February 15, 2022

REQUEST

Rockwood Homes LLC (Applicant) requests the rezoning of Parcel No. 5404304013 (±9.8 AC) from the PUD CAD-O (Commercial/Hotel District with Commercial Airport District Overlay) to the RM-30 (Residential Multifamily) CAD-O District. The parcel is located in the southwest corner of the Claremont Ranch subdivision (See Vicinity Map for Details), specifically the northeast corner of Marksheffel Road and US 24 intersection.

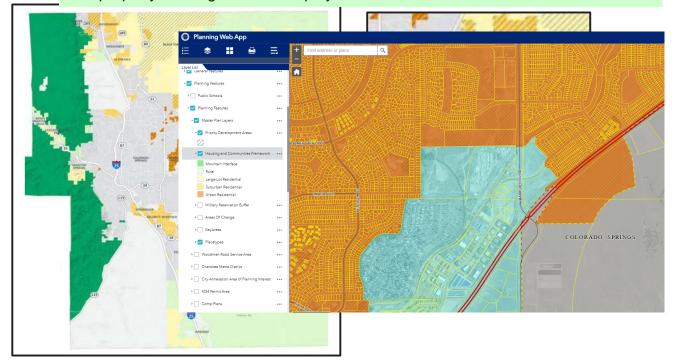
According to the Priority Development Areas Man in the Master Plan the site is located within an U The property is not located within an urban residential priority development area nor be pl is it an urban residential designation in the housing and communities framework. This property is designated as employment center.
